Accessibility Survey

City of Downey Yankey Street - Pomering Road To Cul-de-sac

Date of Inspection 4/17/2017

Disability Access Consultants

North Side @ 33.936133518290, -118.155310302973

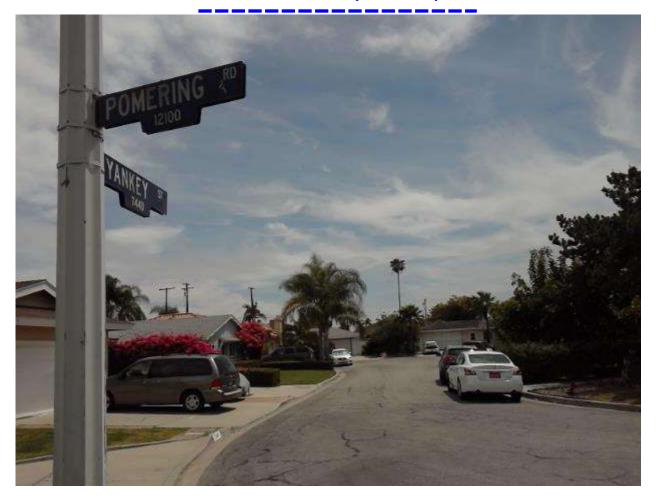
Sidewalks : No Sidewalk

No sidewalk exists at the location.

No action necessary until a sidewalk is provided.

Southwest Corner Of Rives Avenue @ 33.933661149048, - 118.150762617588

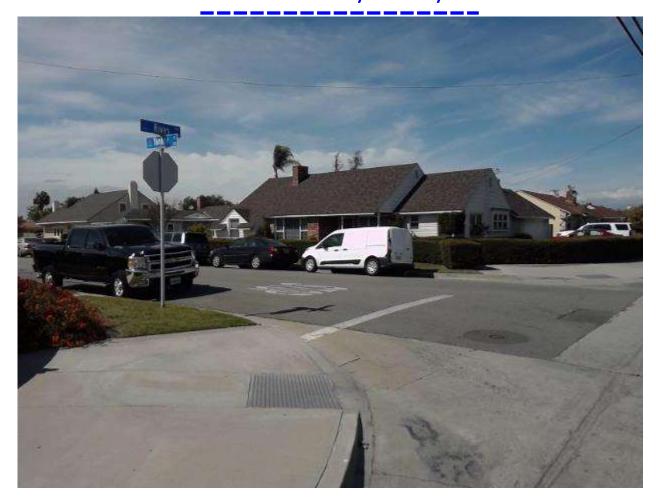
Curb Ramp : Side Flare Slope

The slope of the curb ramp side flare is greater than allowed.

On-Site Finding 12.20 percent

Provide curb ramp side flares with a compliant slope.

Recommendation Up to 10.00 percent
